REVISED RESPONSE TO REQUEST FOR ADDITIONAL INFORMATION

APR1400 Design Certification

RAI No.: 433-8363
SRP Section: SRP 19
Application Section: 19.1
Date of RAI Issue: 03/08/2016

Question No. 19-75

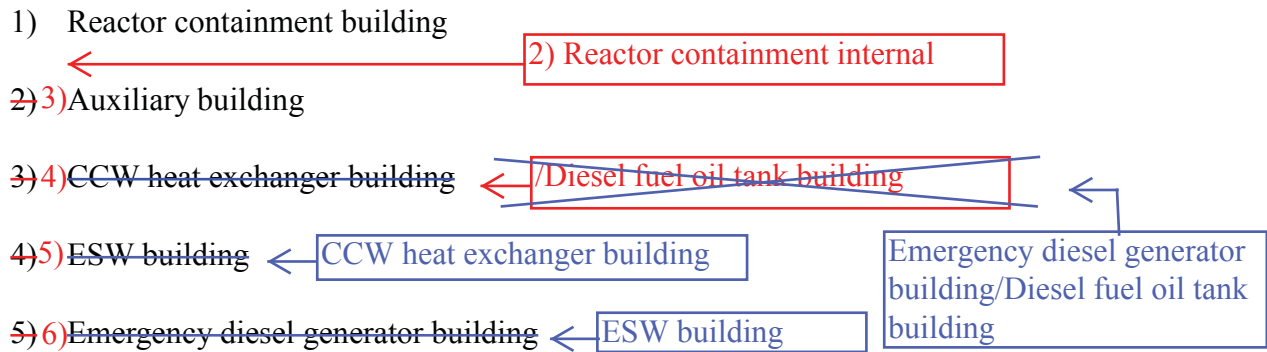
- f. Failure of buildings that are not seismic Category I (e.g., turbine building and compound building) does not impact SSCs designed to be seismic Category I. Seismic spatial interactions ~~between SSCs designed to be seismic Category I and~~

between seismic Category I equipment and non-seismically qualified equipment

~~any other buildings~~ will be avoided by proper equipment layout and design. The following seismic Category I buildings and structures are identified as buildings and structures that involve safety-related SSCs to prevent core damage.
